ADDENDUM NO. 02

Date: March 19, 2021
Project Name: Apron Design Phases 2 Through 6
Owner: City of Clinton, MO
Garver Project No. 19A15701

APRON DESIGN
PHASES 2 THROUGH 6

JOINT ELEVATION
PLAN I - PHASE 2
(BASE BID)

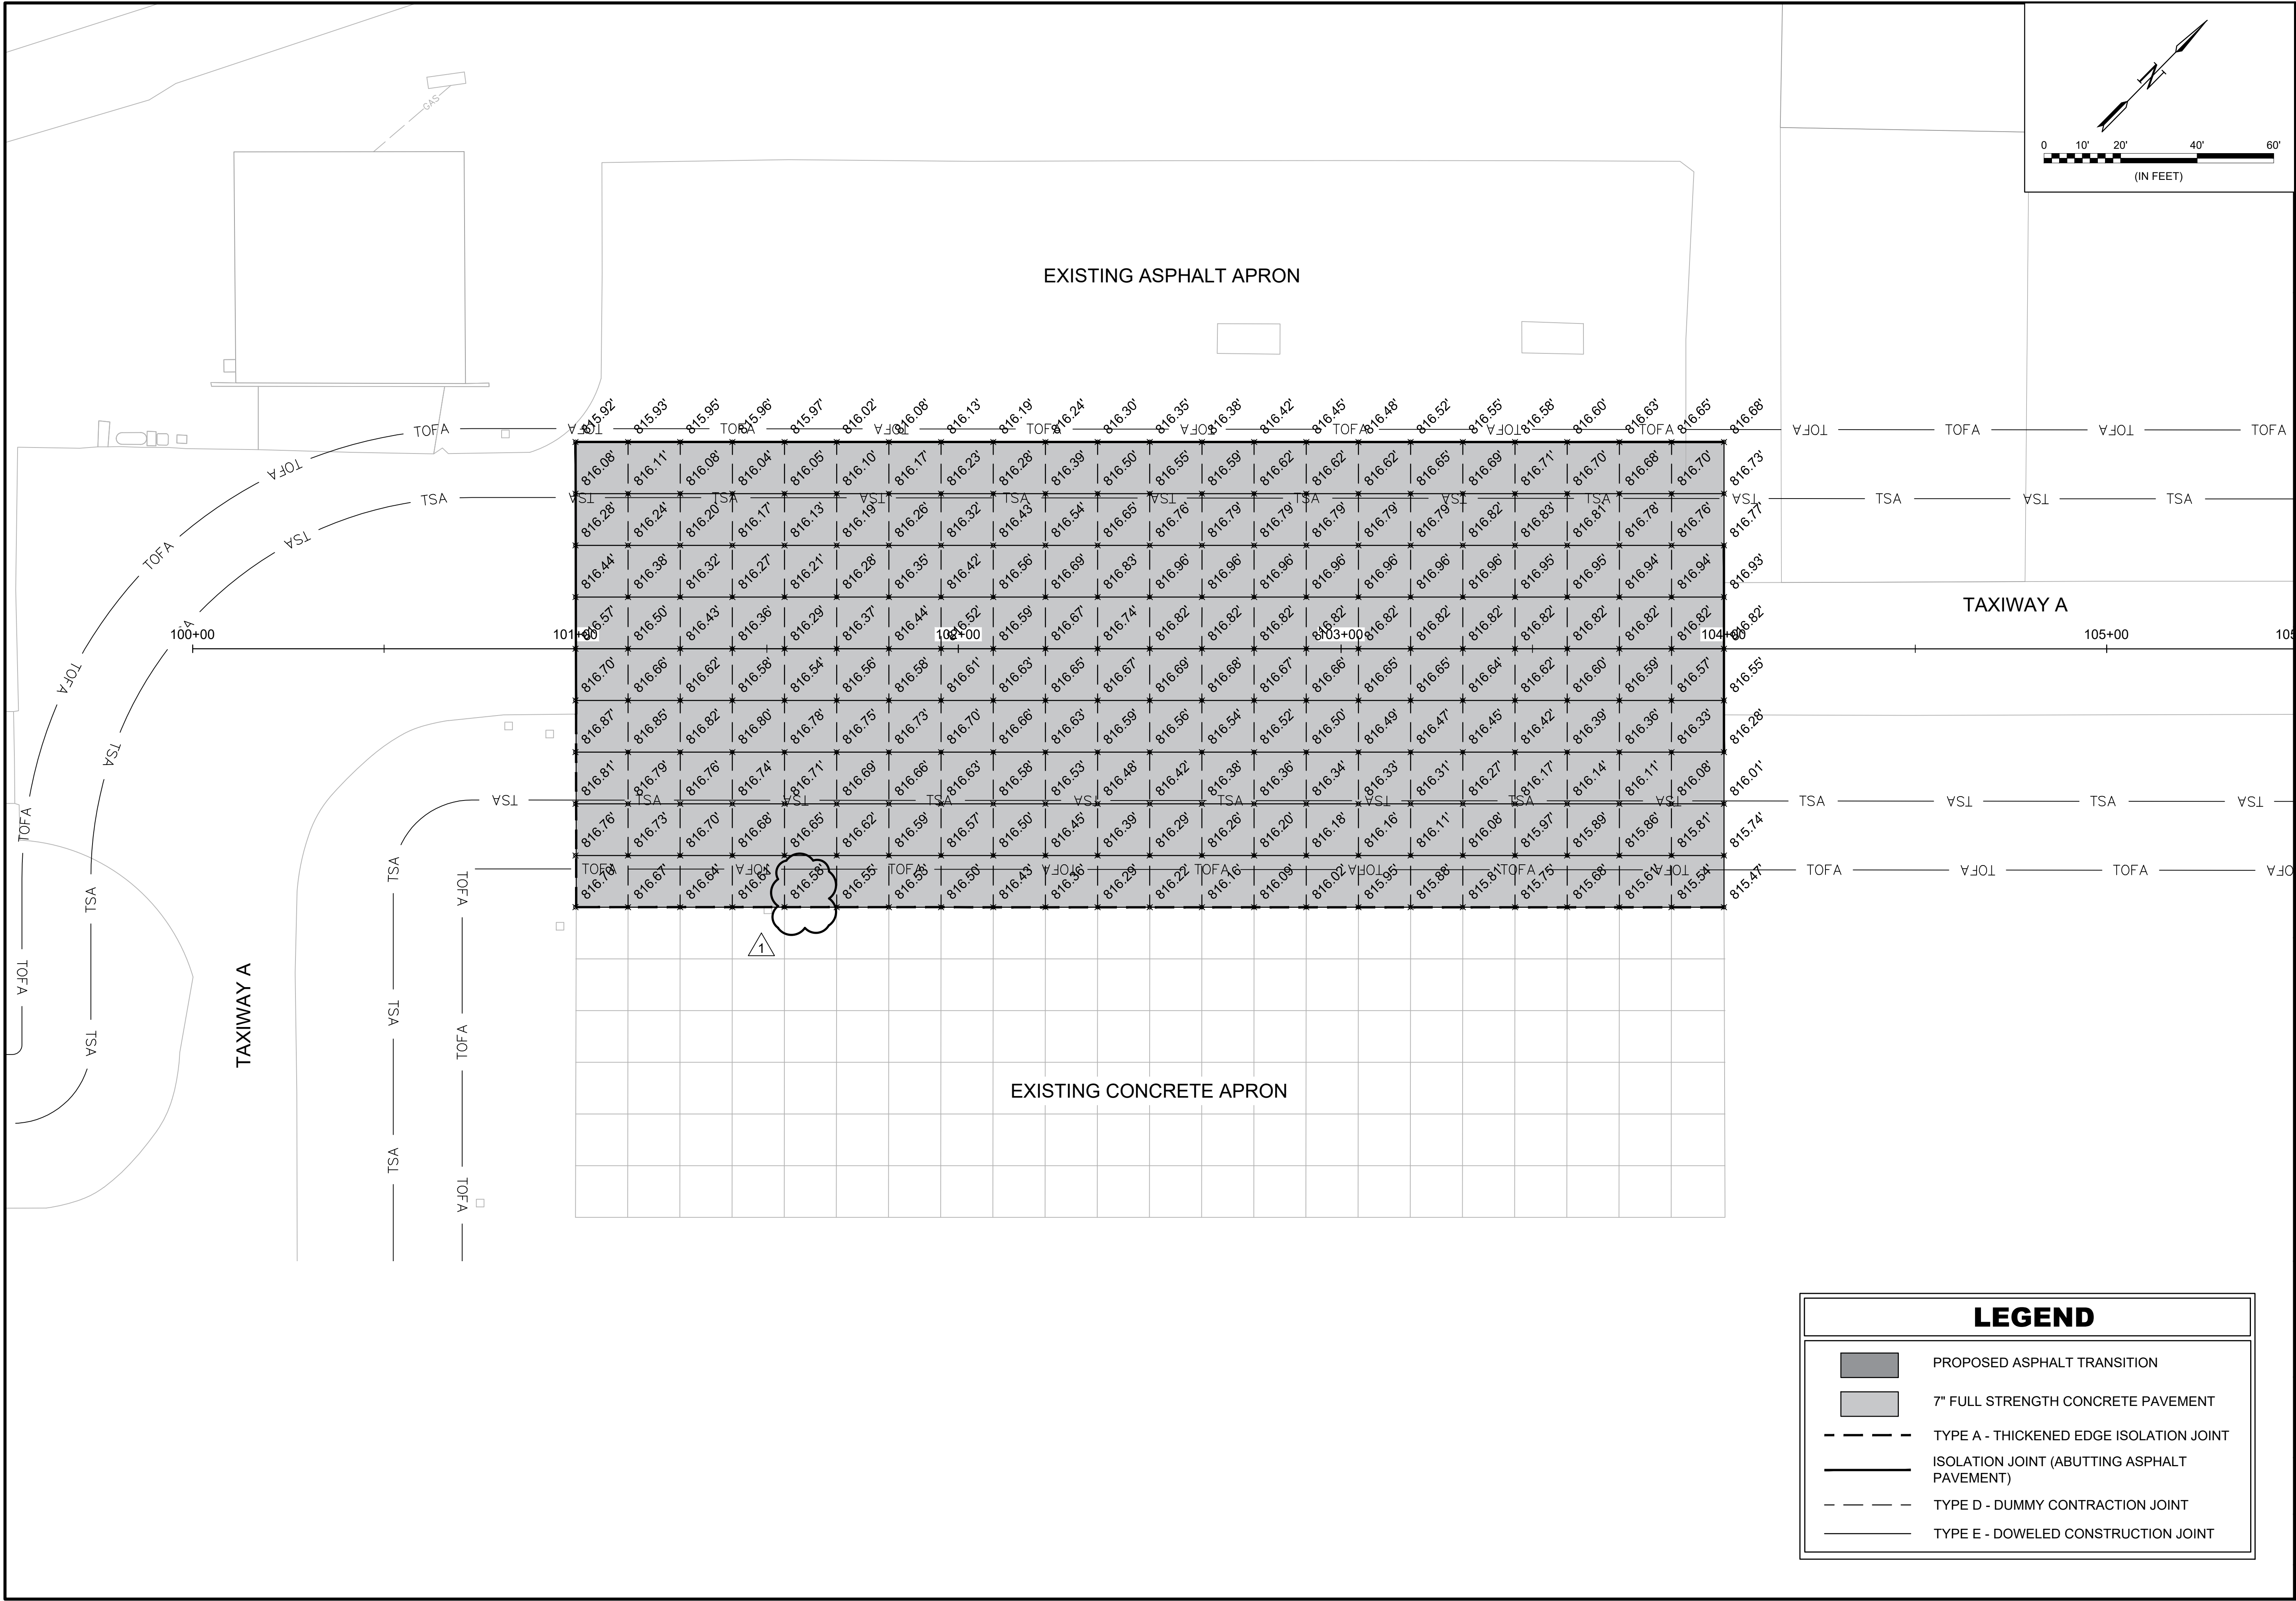
1. Remove Drawing C-203 and replace with the attached Drawing C-203. Change includes clarifying a spot elevation.
2. Remove Drawing C-302 and replace with the attached Drawing C-302. Changes provide more detailed contour lines and information in plan view for the Base Bid.
3. Remove Drawing C-303 and replace with the attached Drawing C-303. Changes provide more detailed contour lines and information in plan view for the Additive Alternate.
